**PUD &
SUBDIVISION STAFF REPORT****Date: April 3, 2003**

DEVELOPMENT NAME Heron Lakes Subdivision, Phase Two, "Corrected Plat",
Resubdivision of Lots 110, 111, and 112.

CONTEMPLATED USE Amend previously approved PUD to allow reduced side
yard setbacks in a single-family residential subdivision.

SITE PLAN

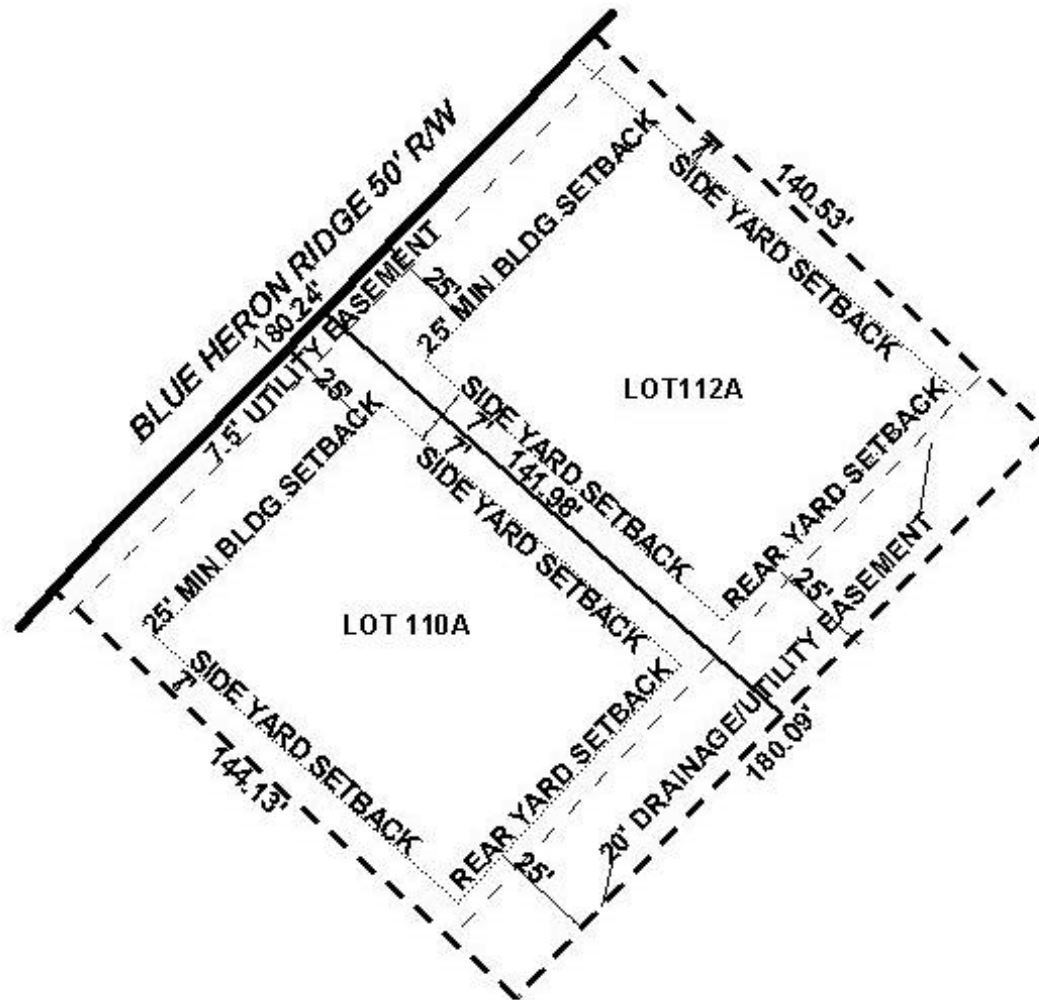
The plat as submitted reflects reduced side yard setbacks; and based on the building limits as shown, appears to increase site coverage above 35%. However, a subsequent discussion with the engineer about the specifics of the original PUD approval (reduced setbacks applied only to lots less than 65' in width and the 35% maximum site coverage was not changed) found that reduced setbacks and increased site coverage were not needed since the proposed lots would be approximately 90' x 141', or 12,690 sq.ft.. Therefore, a revised plan without the reduced setbacks or building limits should be submitted for the file, and the reduced setbacks or building limits should be removed from the final plat.

Subdivision: With minor modifications, the plat meets the minimum requirements of the Subdivision Regulations and is recommended for Tentative Approval subject to the following conditions: 1) reduced setbacks or building limits be removed for the final plat; and 2) placement of the 25' minimum building setback line on the final plat.
